# C8051T610/1/2/3/4/5/6/7 Revision C Errata

### **Errata Status Summary**

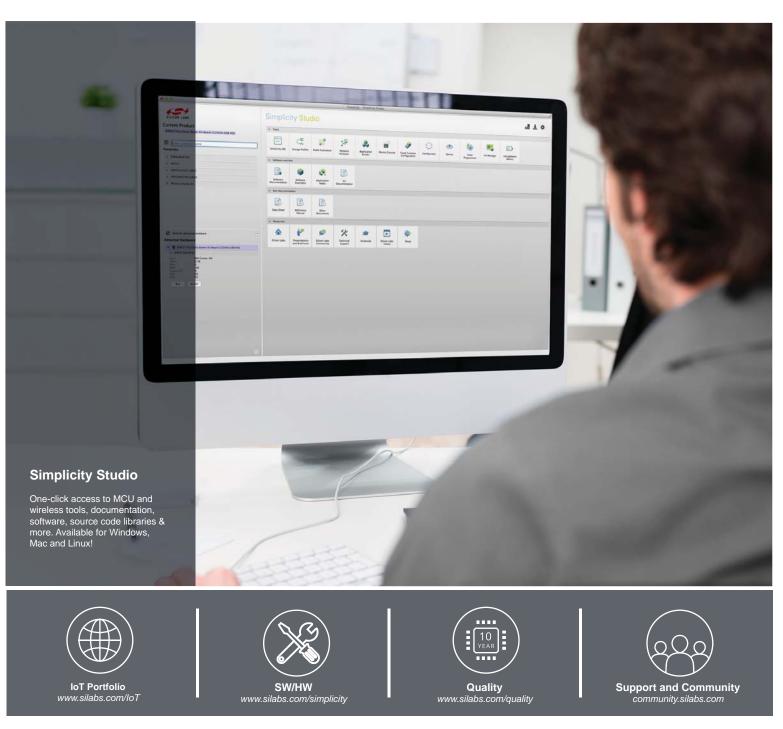
Description: A change is being made to the specified programming voltage (V<sub>PP</sub>) for the device, in order to improve the effectiveness of programming operations. At higher V<sub>PP</sub> voltages, there is a possibility that programming a byte in the EPROM memory will also unintentionally program other bytes in the memory. To eliminate the possibility of this happening, the specifications for minimum, typical, and maximum V<sub>PP</sub> voltage are all being reduced by 0.5 V. We are implementing this change in two stages.

Stage 1) For devices with date code prior to 0935, the maximum  $V_{PP}$  voltage specification is being reduced from 6.75 V to 6.5 V and the typical specification for this parameter is being reduced from 6.5 V to 6.375. The minimum specification of 6.25 V is not changed for these devices.

Stage 2) For devices with date code 0935 and later, the maximum V<sub>PP</sub> voltage is being reduced to 6.25 V minimum V<sub>PP</sub> voltage is being reduced to 5.75 V, the typical V<sub>PP</sub> voltage is being reduced to 6.0 V, and the minimum V<sub>PP</sub> voltage is being reduced to 5.75 V.

**Impact:** A small percentage of devices programmed with  $V_{PP}$  voltages above the specifications may exhibit programming failures. These will be easily detectable by performing a read-verify operation of the EPROM contents. It is very important that the minimum  $V_{PP}$  specification is observed for all devices. Devices are screened for EPROM data retention down to the specified levels (6.25 V for date codes before 0935, and 5.75 V for date codes 0935 and later). EPROM data retention cannot be guaranteed if devices are programmed with lower voltages.

**Workaround:** It is recommended that any existing programming hardware using the previous  $V_{PP}$  specification be modified to apply between 6.25 V and 6.5 V to  $V_{PP}$  during programming operations. Devices with date code 0935 and later can safely be programmed at the lower  $V_{PP}$  specification.
